Technical Service Bulletin

Topic	93 e-tron update OBC software when replacing HV wiring harness for charging socket - NTC to PT1000 charging socket
Market area	United States 444 Volkswagen of America, Inc. (6444)
Brand	Audi
Transaction No.	2070110/5
Level	EH
Status	Released for publishing
Release date	Apr 23, 2025

Figure 1. High-voltage wiring harness for charging socket.

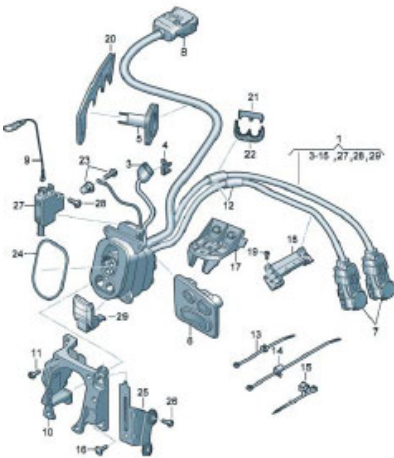
The High Voltage Wiring Harness for the charging socket UX4 or UX5 is replaced as part of any repair work (Figure 1).

The charging socket was modified in production.

It is essential to check the part number of the removed original high-voltage wiring harness and of the new replacement high-voltage wiring harness.

If the high-voltage wiring harness for the charging socket is replaced as listed in Table 1.2, an SVM code will need to be performed, *and a replacement test plan performed.*
